Contract No. HY/2010/08
Central – Wan Chai Bypass – Tunnel (Slip Road 8 Section)
Submission of Additional Mitigation Plan for Slip Road 8 (Revision 7) under condition 2.16 of FEP-10/364/2009/B

**Central – Wan Chai Bypass Tunnel
(Slip Road Section 8)
Contract No. HY/2010/08**

Additional Mitigation Plan for Slip Road 8 under condition 2.16 of FEP- 10/364/2009/B

Revision: 7

SKETCH NO. 60095653/T2/SK0690 SCALE 1:500(A3)

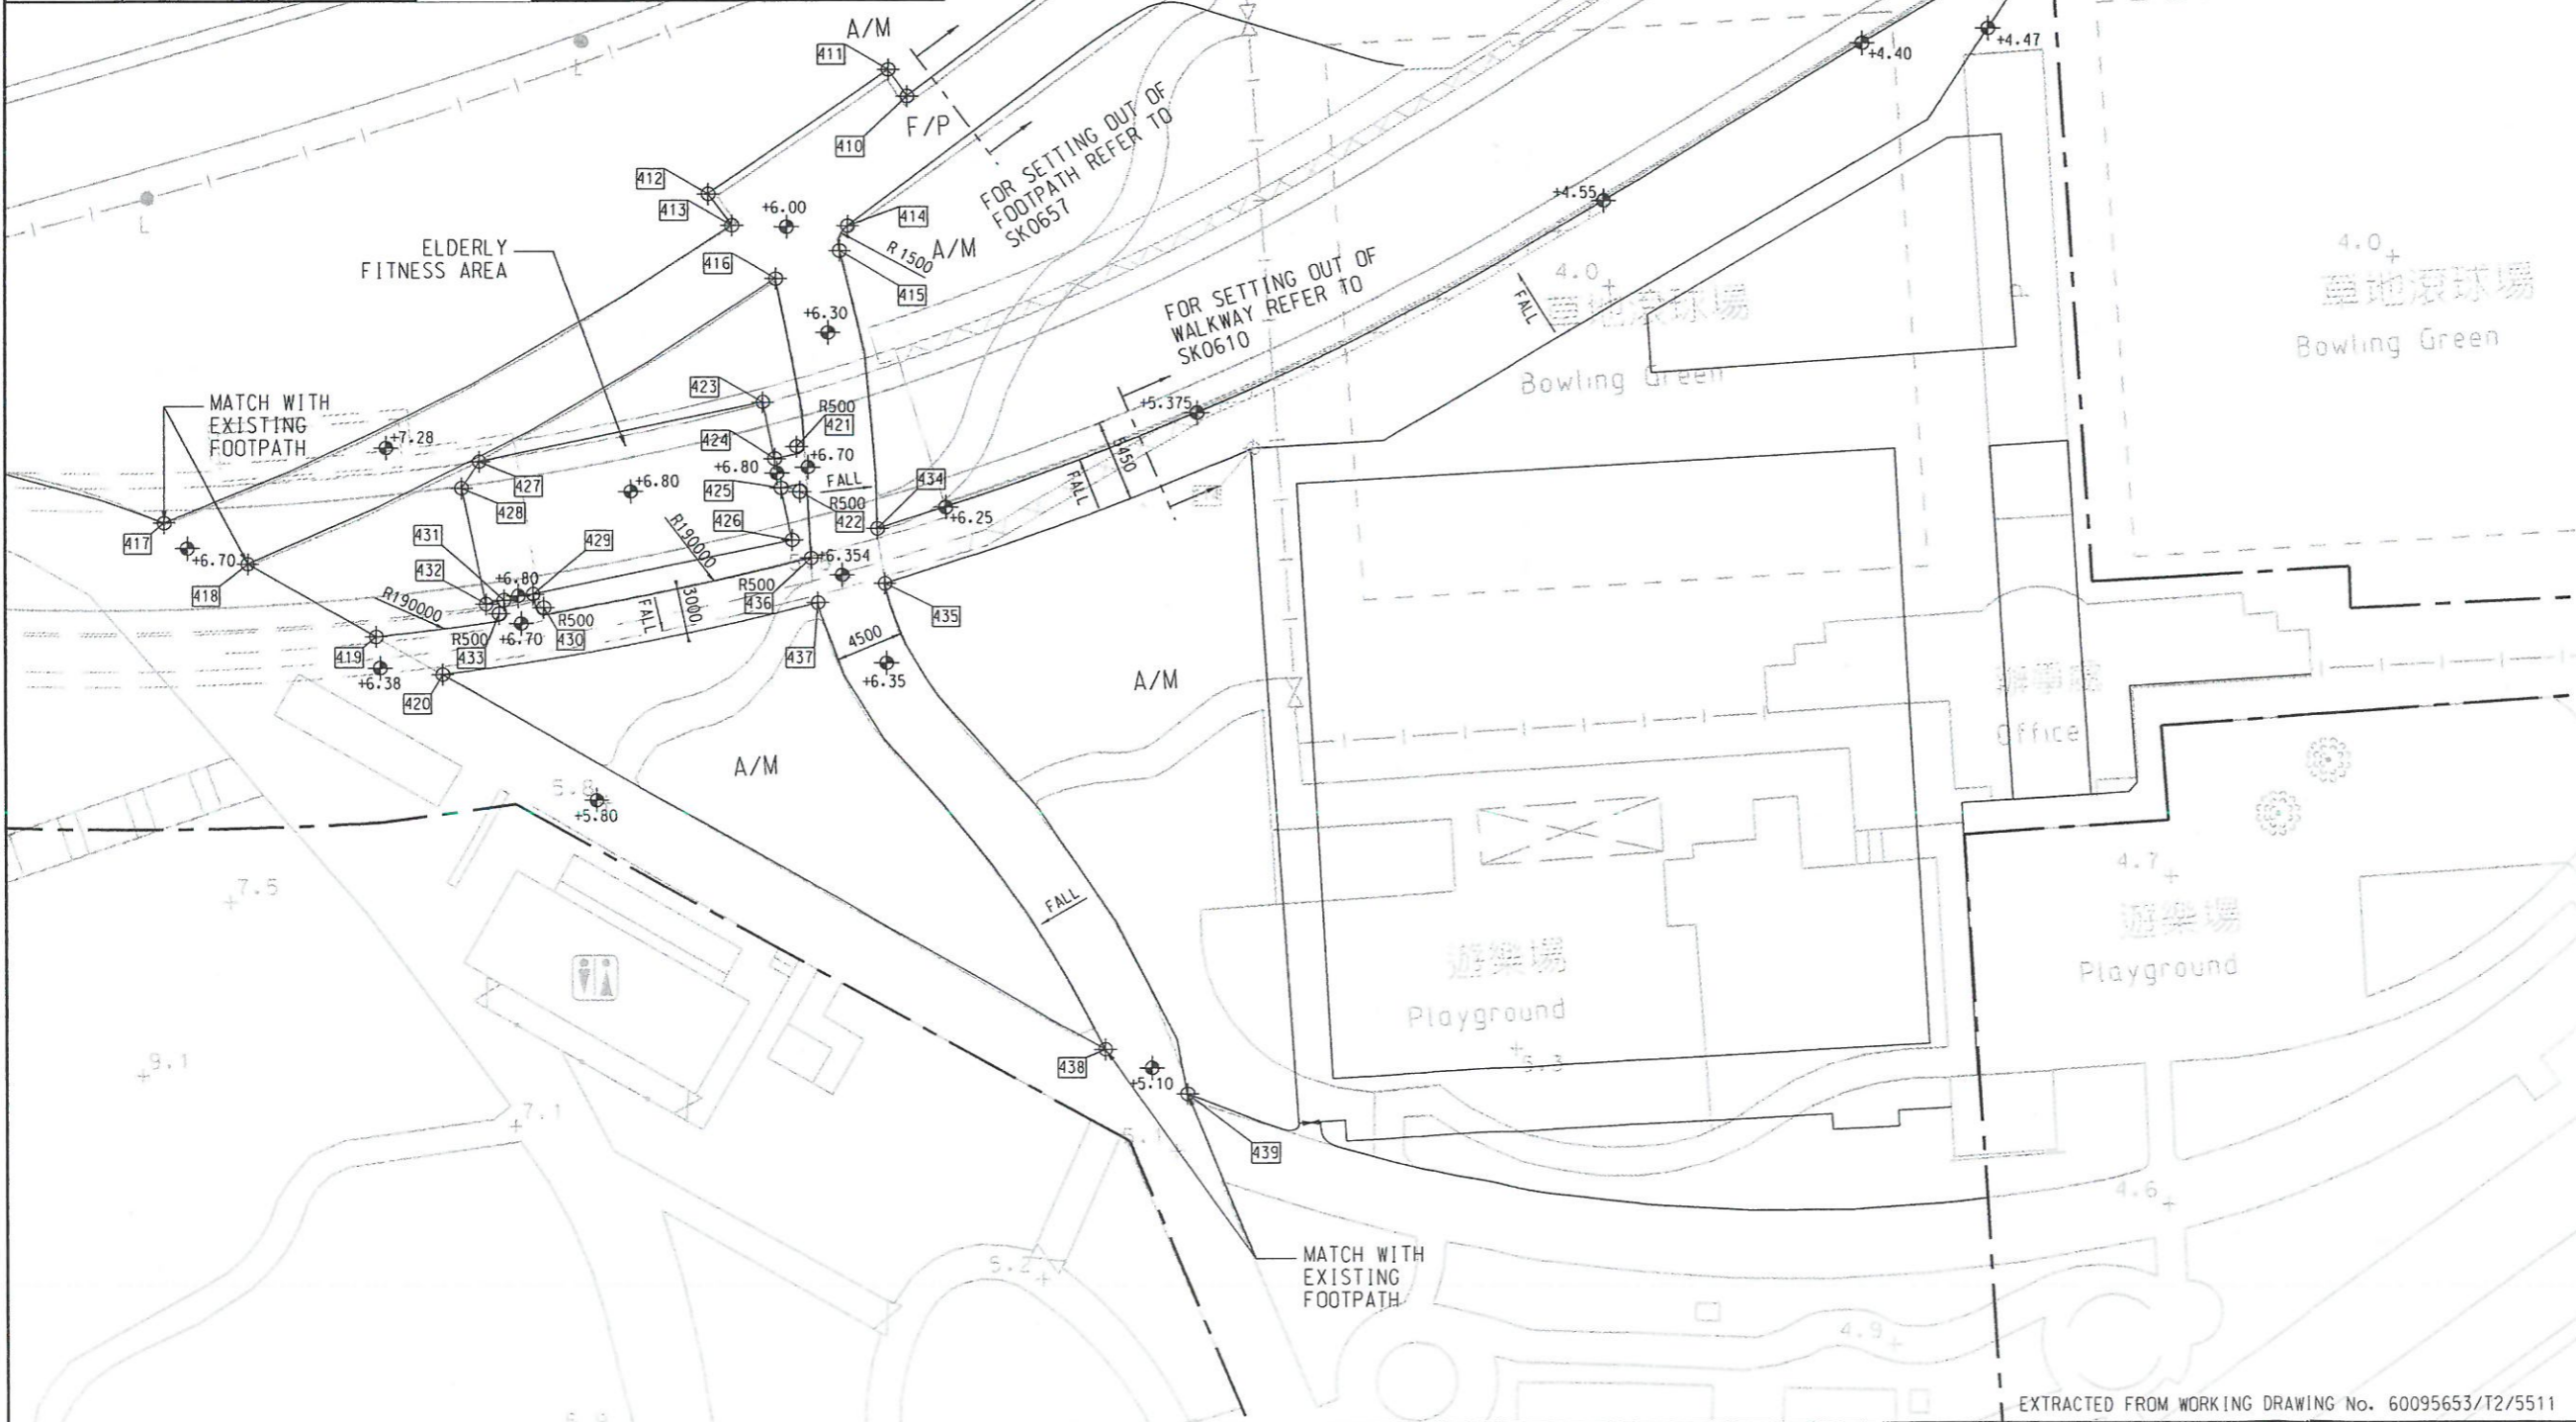
I enclose for your construction a copy of Sketch No. 60095653/T2/SK0690 showing the setting out details for the elderly fitness area and the adjacent footpaths within Victoria Park.
